UNITED STATES
DEPARTMENT OF THE INTERIOR
BUREAU OF LAND MANAGEMENTFORM APPROVED
OM B No. 1004-0137
Expires: March 31, 2007**RECEIVED**
OCT 24 2008
HOBBS, NM**SUNDRY NOTICES AND REPORTS ON WELLS**

West Blinebry Drinkard Unit #020W

Pursuant to R-12981 effective 9/1/2008, Apache proposes to convert this well to injection via the following procedure:

WELL DATA SHEET

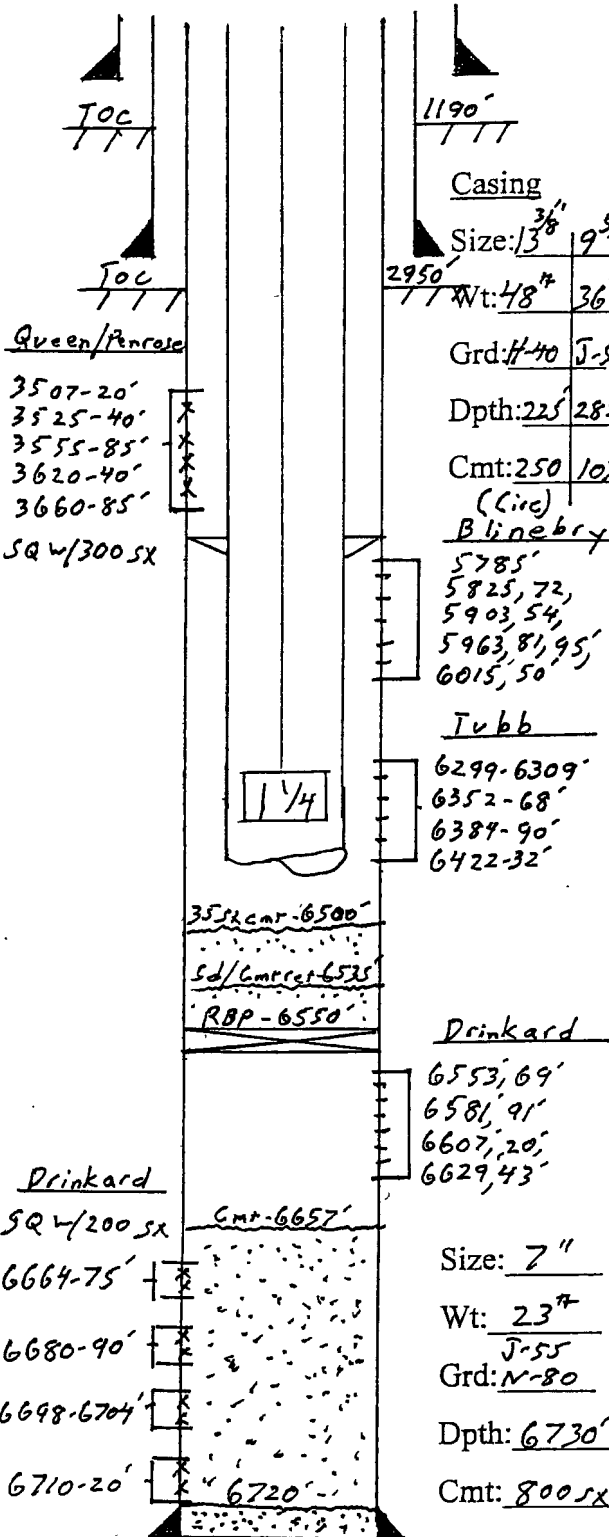
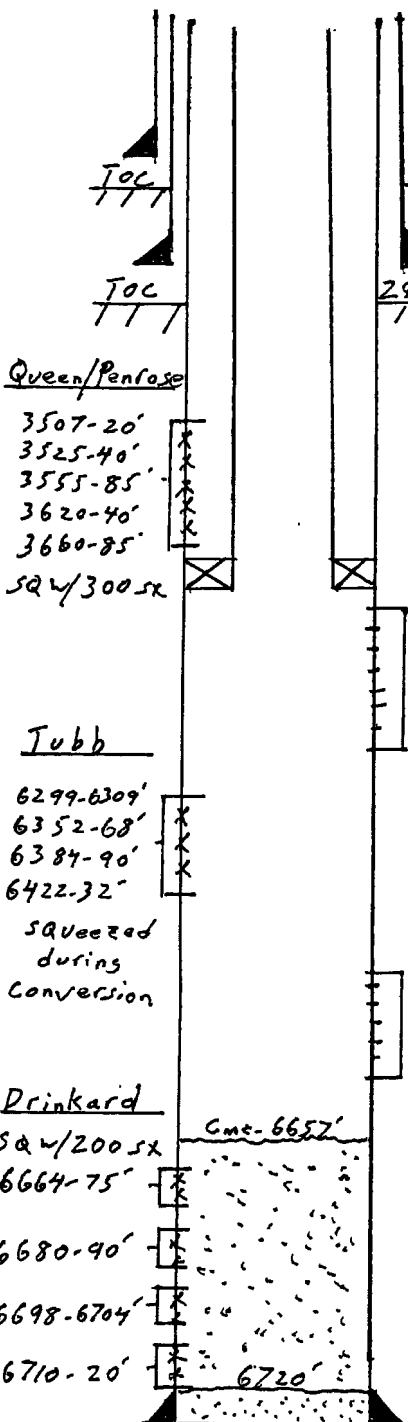
This well is currently producing from the Blinebry/Tubb with cmt plugs and RBP over the Drinkard.

1. MIRU.
2. POOH w/ production equipment.
3. Isolate and squeeze Tubb interval from 6299' - 6432'.
4. Drill out and test squeeze.
5. Drill out cmt plugs from 6500' - 6550'.
6. Retrieve RBP @ 6550'.
7. Clean well out to PBTD @ 6557'.
8. Isolate & acidize Drinkard 6553' - 6643'.
9. Isolate & acidize Blinebry 5785' - 6050'.
10. RIH w/ IPC injection tubing & packer to 5700'.
11. Notify BLM office prior to pressure testing casing per BLM regulations.
12. Set up surface equipment.
13. Begin injection in the Blinebry/Drinkard.
